SITE PLAN REVIEW AND APPEARANCE BOARD STAFF REPORT

File No.: 2016-097-SPF-SPR-CL5

Application Type: Class 5 Site Plan – 5th Avenue Square

5th Avenue Square

Forecourt Design

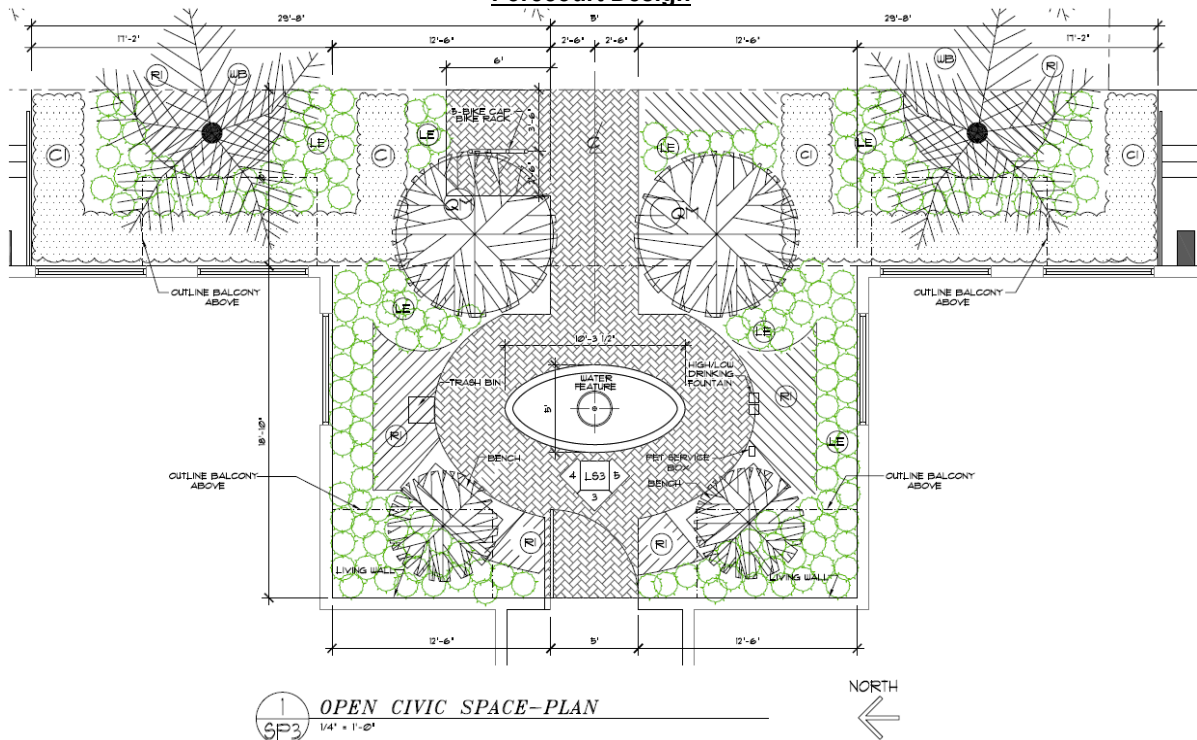
- ✓ The plans show a forecourt in accordance with civic open space requirements for developments within the CBD, in accordance with LDR Section (G)(2)(g). The forecourt as designed has a depth of 19' feet from the building façade, and a width of 20'. As shown on page SP3, the forecourt includes civic amenities such as a trash receptacle, park benches, pet service area, living landscape wall, drinking fountain, bike rack, and a water fountain as the center feature. Therefore, the proposed design meets this requirement.

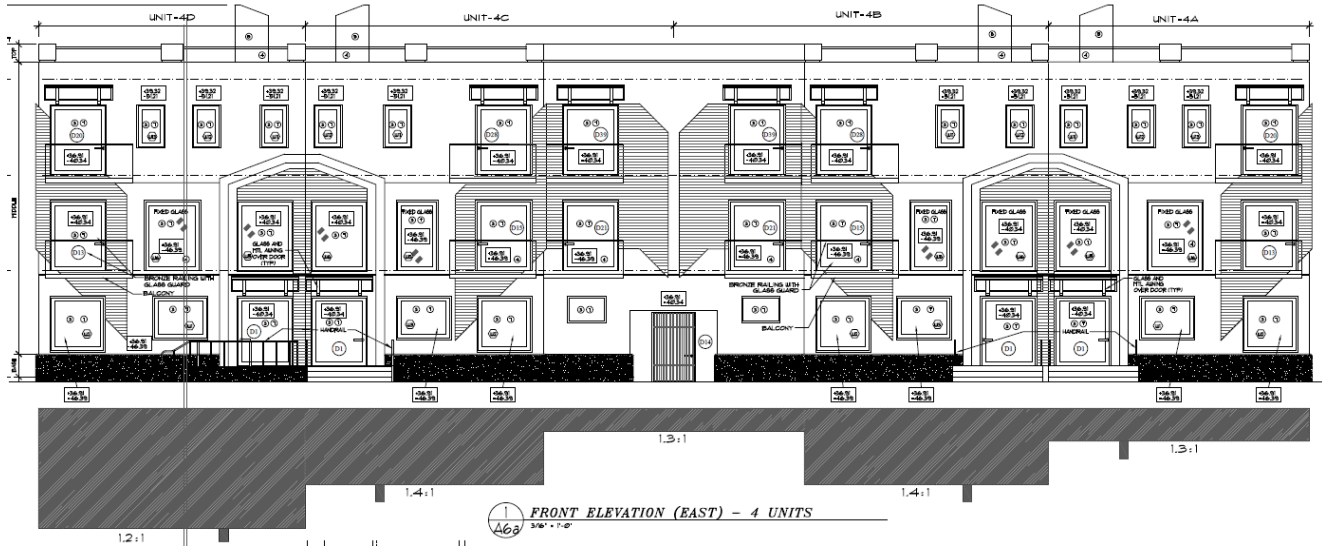
- ✓ The plans show that the proposed façade design for the 4-unit building and property manager buildings facing SE 5th Avenue that do not exceed a 3:1 or 1:3 height to width ratio; thus, complying with this comment.
